# Delegated Report

## Full Planning Application

**Planning Application No:** 20220642

**Location:** Land Adjacent To 28 Coutts Avenue Shorne Gravesend Kent

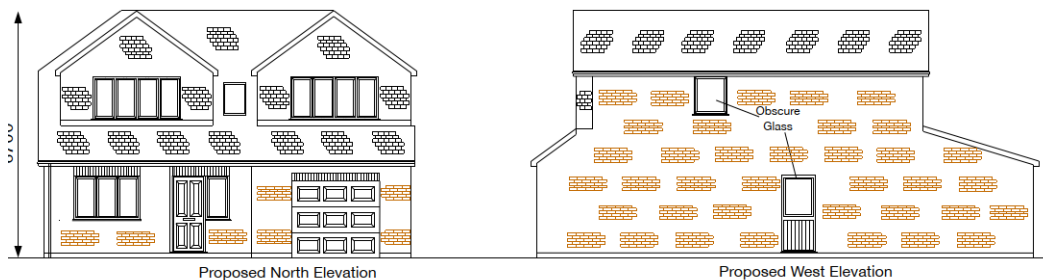
Whilst the proposal may seek to make a more efficient use of the site, and would provide 3 additional dwellings, this should not be outweighed by the clear development plan objectives that include maintaining and improving the character of the area. The proposed dwelling will sit on a prominent and obviously smaller plot than its surrounding counterparts, and will result in a clearly cramped over-development of the site that would be out of keeping with the character and appearance of the layout of the properties in the immediate area. This is demonstrated below.

On this basis, the proposal is considered to be contrary to the requirements of Policies CS15 and CS19 of the Core Strategy 2014, and paragraphs 119, 124, 126 and 130 of the NPPF 2021.

Proposed West Elevation

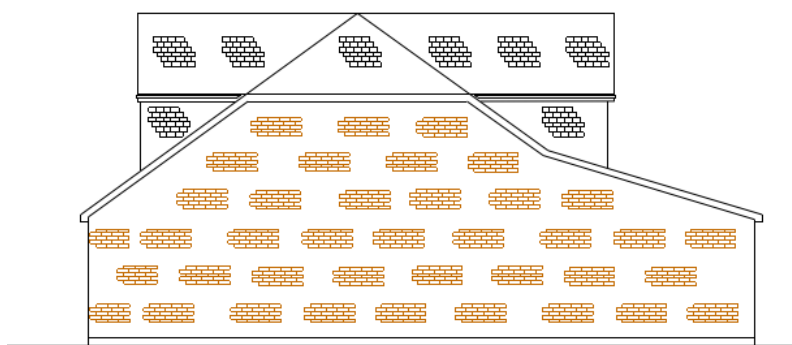
The introduction of development will result in in an oppressive from of development only 1 metre from the boundary of 26 Coutts Avenue, as demonstrated below.

It is considered the proposed development will result in an unneighbourly form of development that will impact on the outlook from the adjacent property. As such the proposal is contrary to Policy CS19 (LPCS).
